UNITED STATES  
NUCLEAR REGULATORY COMMISSION  
WASHINGTON, D. C. 20555

APPLICANT: ABB-Combustion Engineering, Inc. (ABB-CE)  
PROJECT: CE System 80+  
SUBJECT: PUBLIC MEETING OF JANUARY 26, 1994, REGARDING IN-CONTAINMENT  
REFUELING WATER STORAGE TANK (IRWST) PH CONTROL AND THE USE OF THE  
NEW SOURCE TERM FOR THE ABB-CE SYSTEM 80+ STANDARD PLANT DESIGN

PARTIAL PLAN OF HOLDUP VOLUME TANK AREA

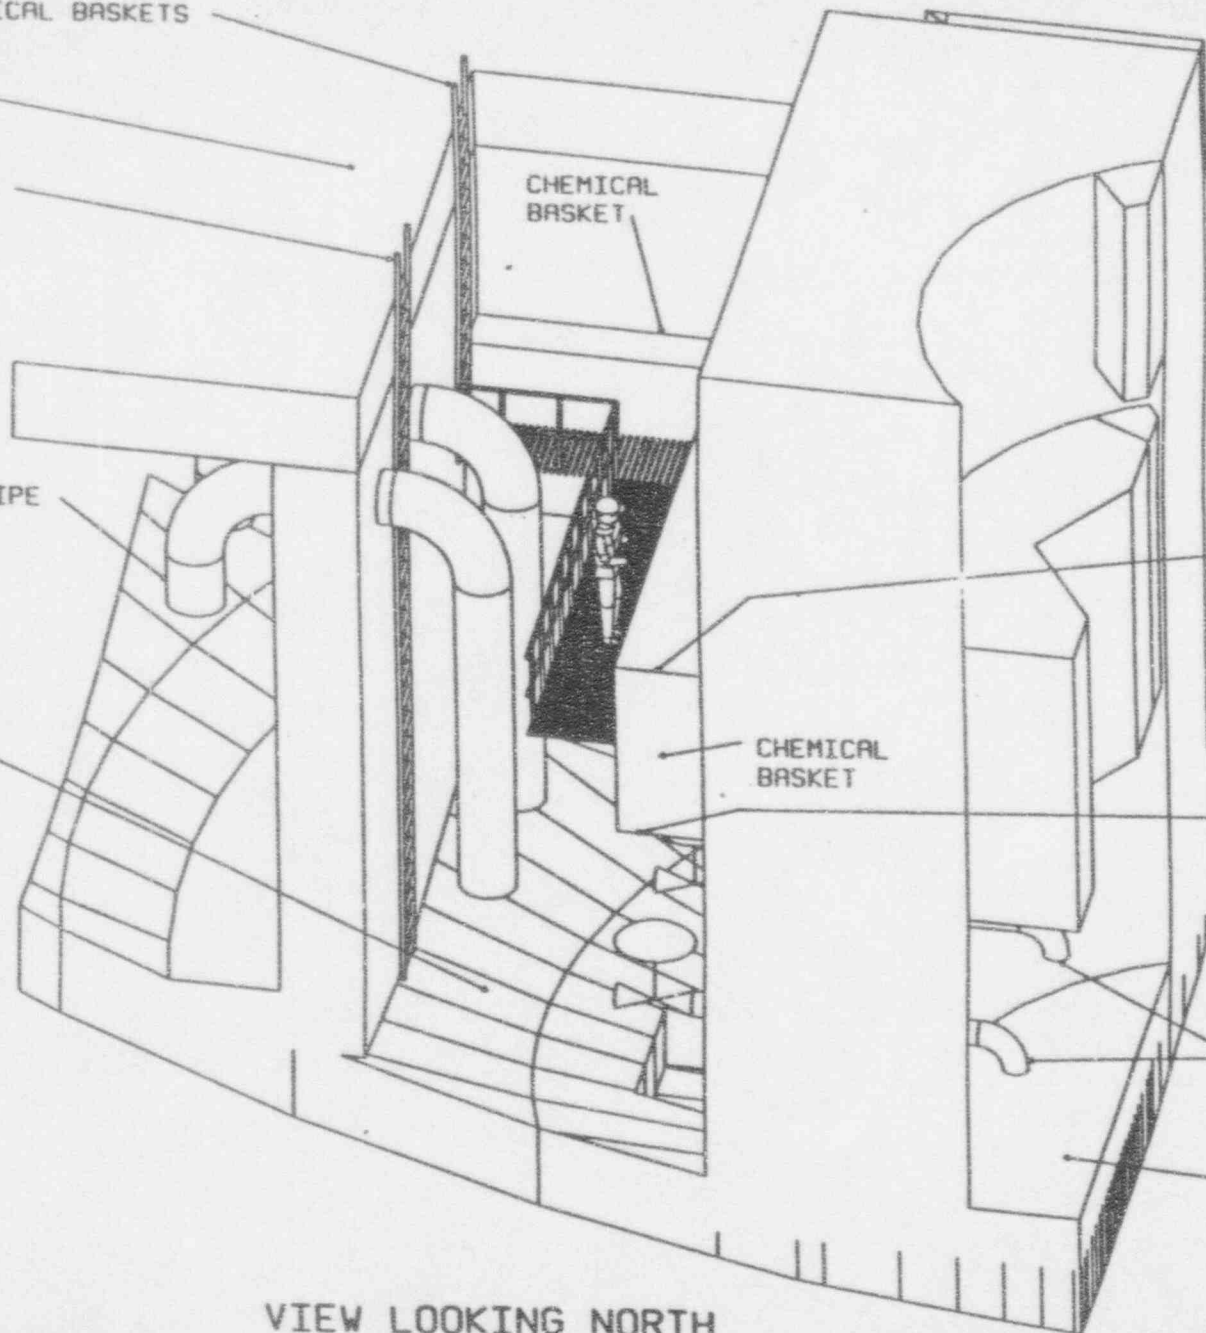
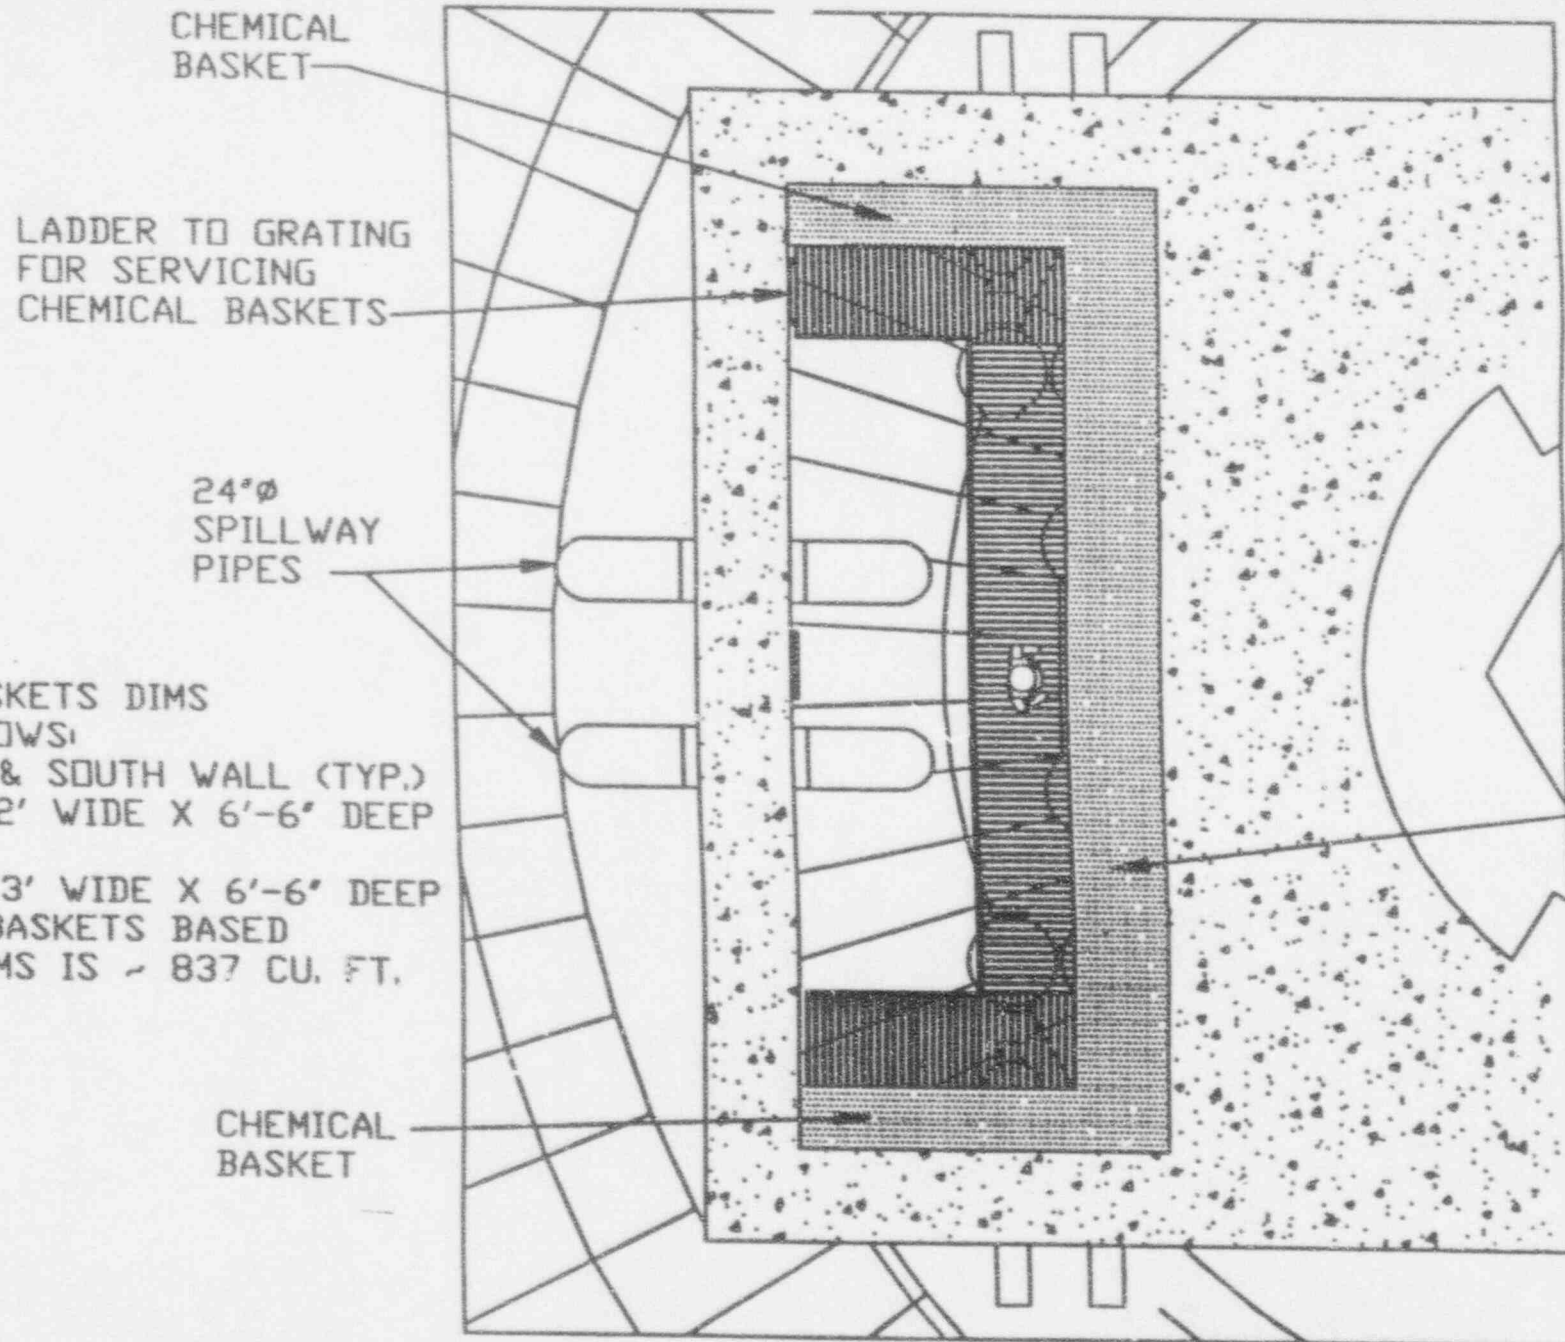
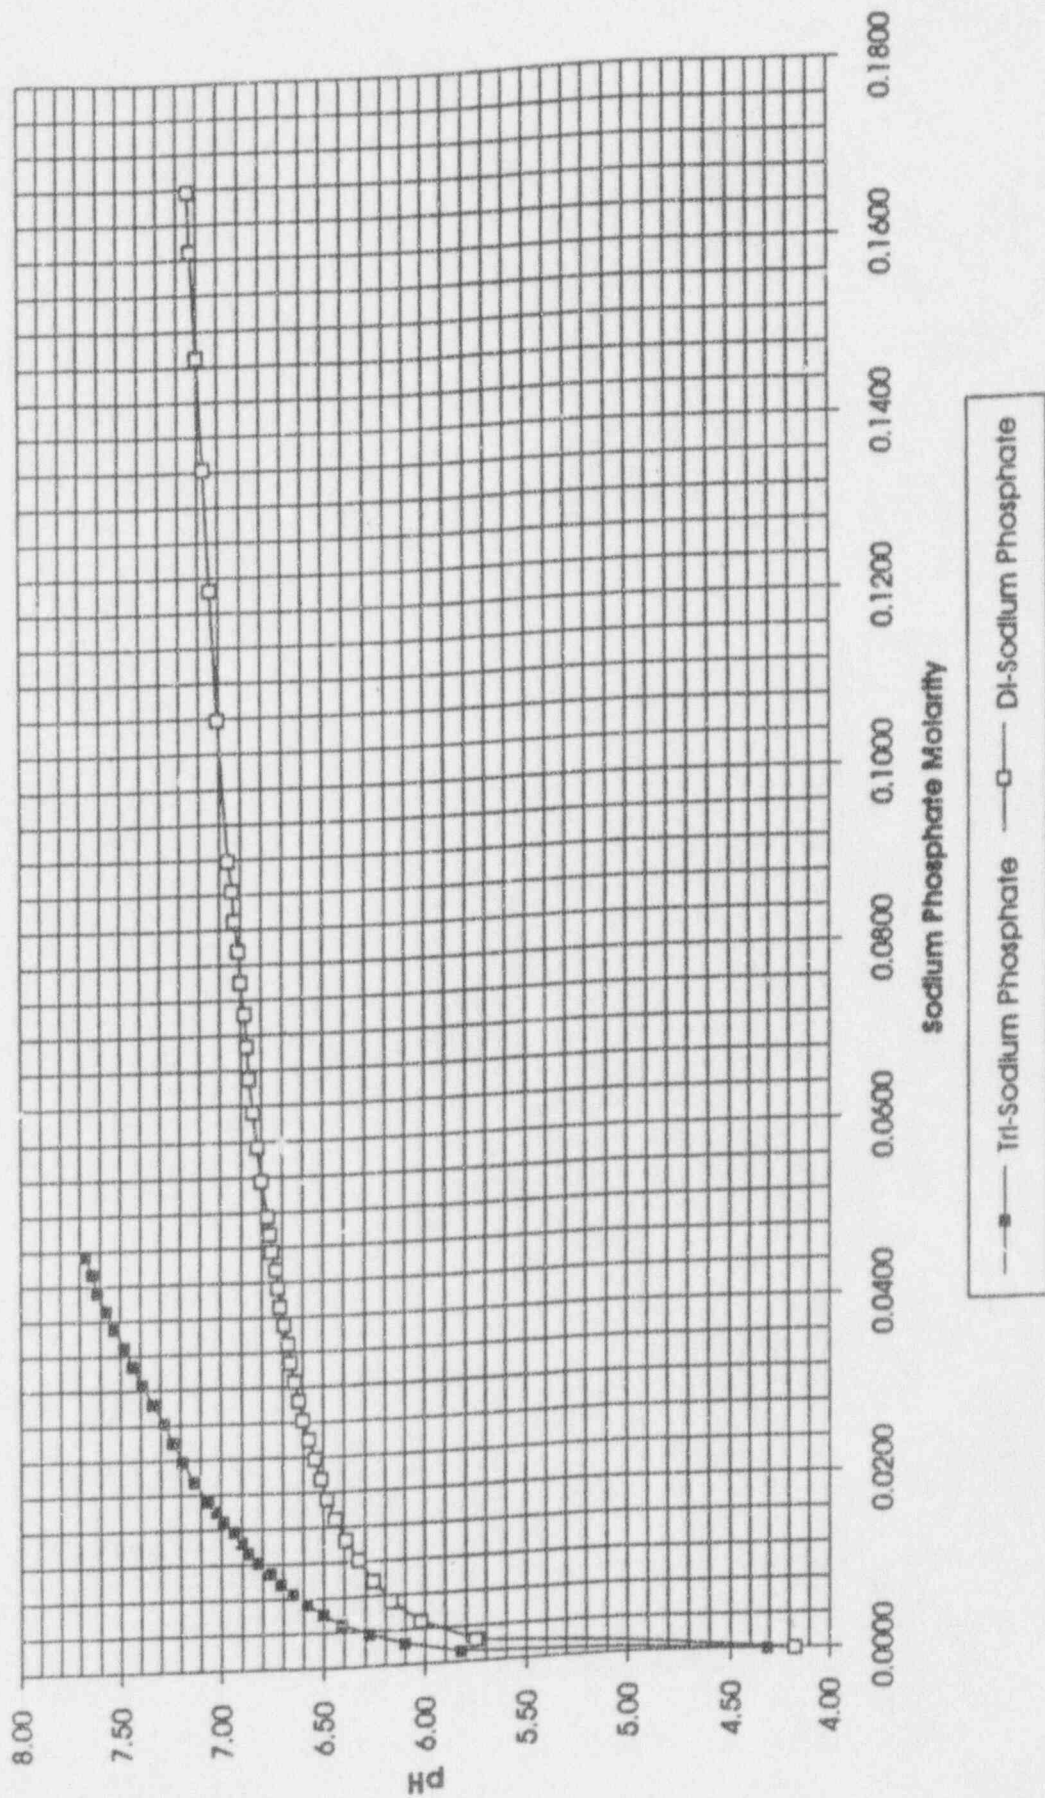
ABB-CE and their contractors stated, in their presentations, that a pH of 7.0 is reached in the IRWST within two and a half hours after an accident. The staff raised questions about the completeness of the analysis performed. After some discussion, it was agreed that ABB-CE should increase the amount of trisodium phosphate dodecahydrate stored inside containment to an amount sufficient to maintain a concentration of 2,000 ppm. ABB-CE committed to revise CESSAR-DC to reflect this. The staff committed to discuss this issue with experts at Oak Ridge National Laboratory and to provide feedback to ABB-CE as soon as possible.
